May 4, 2015

Vickery Meadow Pedestrian Road Safety Assessment (PRSA)

**Conducted:
February 24-26, 2015**

**At the Request of:
City of Dallas**

Figure 15: Large trucks heading to transfer station

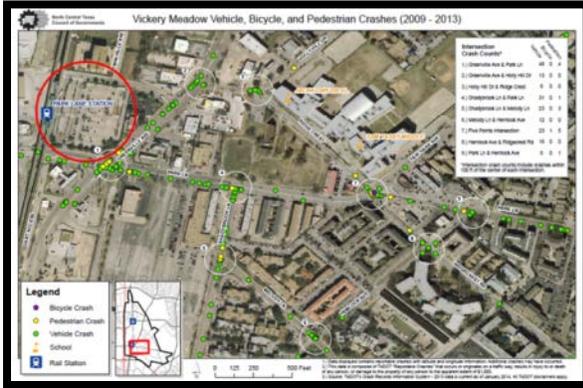
It was discovered that there is a refuse transfer station across from the high school near Fair Oaks Ave and Walnut Hill Ln. The route currently used by the refuse semi-trucks travels through the 5-Points intersection and along Fair Oaks Avenue and Park Lane (Figure 15). The trucks were observed traveling through during school dismissal hours. This truck traffic is not compatible in a neighborhood environment with schools and high pedestrian activity.

- Suggestion: Look into other travel routes for trucks that do not travel along Park Lane, 5-Points Intersection, and Fair Oaks.
- Suggestion: If rerouting is not possible, do not allow trucks during peak school dismissal periods.

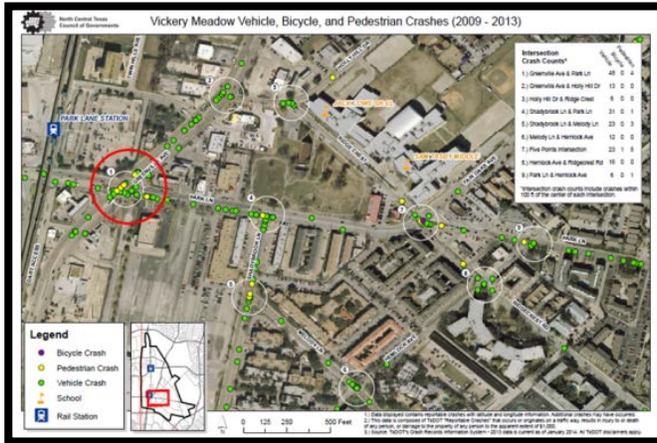
2. There are multiple locations on the east side of the DART station parking lot where pedestrians are exiting (Figure 20 & 21 red arrows) and crossing midblock instead of walking 110 to 130 feet to the signalized intersection (Figure 20 yellow arrows). At one location stepping stones were constructed to assist people making their way up the slope of the parking lot but did not direct pedestrians to an appropriate street crossing location.

- Suggestion: Remove the stone steps (Figure 21), add fencing along the edge of the parking lot along Greenville Avenue, and add pedestrian wayward signing and markings through the parking lot so pedestrians will be guided and encouraged to cross adjacent streets at the proper crossing points. Consider re-orienting the parking lot stalls and aisles to direct pedestrians more directly to the corner of Greenville Ave and Park Ln.
- Timeframe: Short to Intermediate
- Cost: Low to Medium

Figure 25: Recommended Street Lighting layout

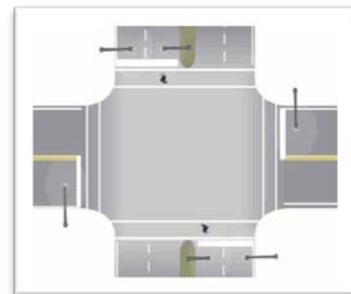
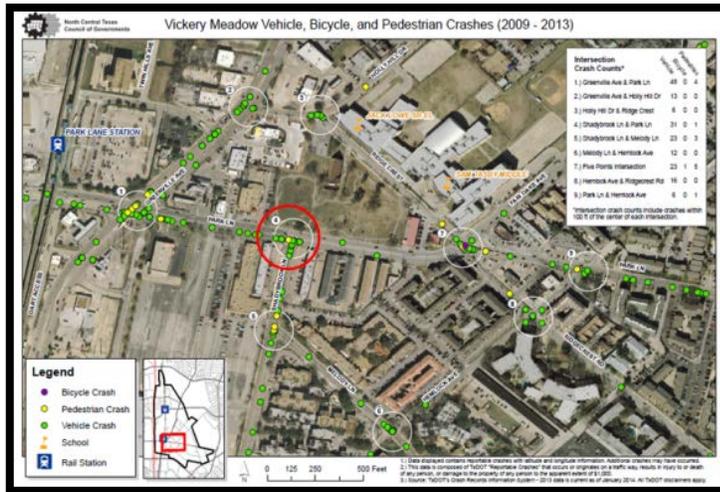
4. Three street lights were within 25 feet of the intersection. The nighttime review revealed lighting could be improved at and near the intersection. On the northwest corner of the intersection there were tree branches which made the corner even darker at night. The tree branches also housed many birds which also took care of “business” directly over where people would be waiting for the pedestrian signal.

- Suggestion: Add street lighting per the recommendation of FHWA-HRT-08-053 April 2008 Informational Report on Lighting Design for Midblock Crosswalks (Figure 25)
- Suggestion: Trim tree branches to improve lighting and not housing birds directly over the sidewalk area (Figure 26).
- Timeframe: Short to Intermediate
- Cost: Lighting–Intermediate to High; Tree trimming–Low

Figure 35: Single Ramp needing top and bottom 4'x4' level landing

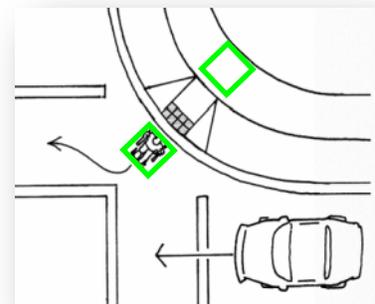
3. Although curb ramps exist, they do not meet current ADA standards. Curb ramps need a level 4'x4' level landing at the top of the ramp so a person in a wheelchair can wait on a level surface and also maneuver a turn (Figure 34). Although single curb ramps are discouraged, if they are installed a 4'x4' level landing is required at the bottom of the ramp as well to maneuver a turn into the correct direction (Figure 35). Truncated domes are also required to indicate to the blind where the edge of the sidewalk is located and that a curb ramp exists.

- Suggestion: Check the City's ADA Transition Plan for when these locations will be brought up to current ADA standards.
- Timeframe: Intermediate to Long
- Cost: Low to High
